**District of Columbia Board of Zoning Adjustment  
Appeal No. 19550**

**Reply Memorandum  
of Advisory Neighborhood Commission 6C**

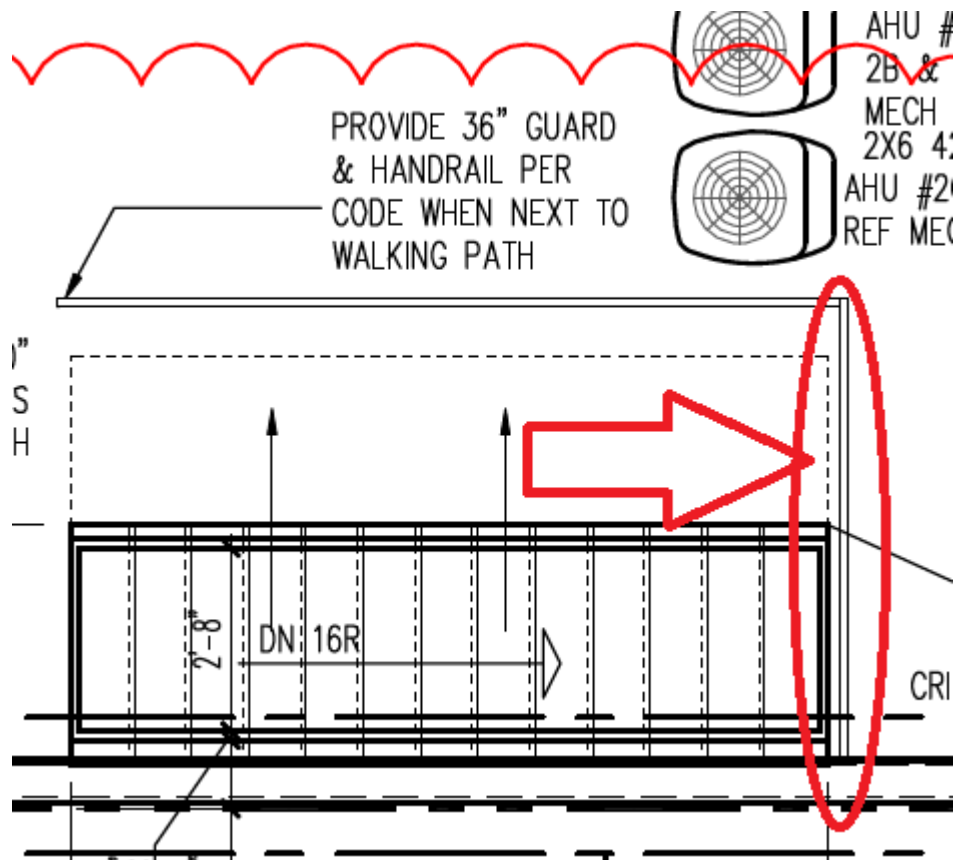
DCRA and the Property Owner doggedly insist that ANC 6C was wrong. However, the Second Revised Permit eliminates these supposedly legal “flip-top” Daylitter penthouses (with enclosing walls of varying, non-uniform height), replacing

each with a lower-profile sliding hatch. This material change adequately responds to ANC 6C's objections to the Daylitter penthouses. As a result, the Board need not consider the arguments presented in Part A of our Second Revised PHS.

**Detail from Sheet A3.1 (Tab A)**

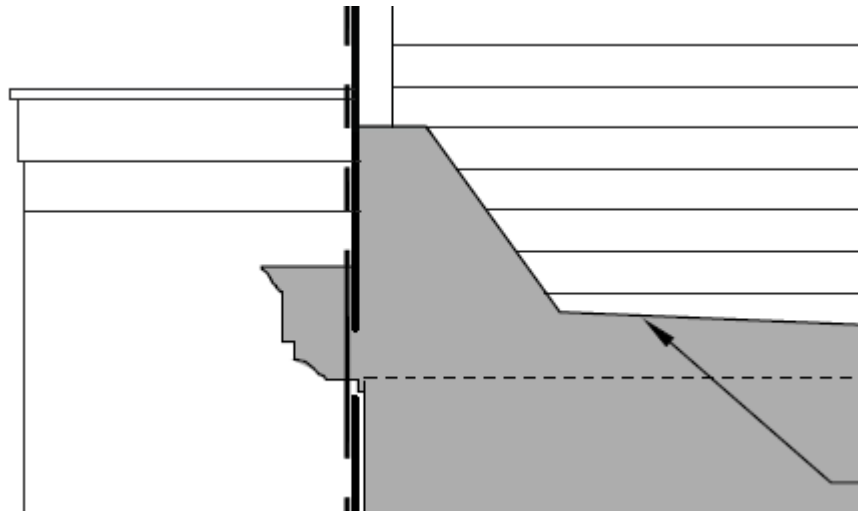
As we noted in Part B (pp. 4-5) of our Second Revised PHS, section 1502.1 of subtitle C mandates that "any guard rail on a roof shall be setback from the edge of the roof upon which it is located" by a 1:1 ratio.

DCRA and the Property Owner offer no response. Both focus exclusively on the setback of the 1'-tall **hatches**, but ignore the adjacent 36" guardrail with zero setback from the edge of the roof. The violation present in the First Revised Permit remains in the Second Revised Permit, as seen on Sheet A3.1:

To avoid uncertainty on this point, ANC 6C emphasizes that the setback requirement applies to **all** rooftop guardrails, including those under 4' in height. See

§ C 1500.2 (requiring setback under section 1502 even for sub-4' roof structures not subject to the rest of section 1500).

The Second Revised Permit therefore violates the zoning regulations; was issued in error by the Zoning Administrator; and must be revoked.
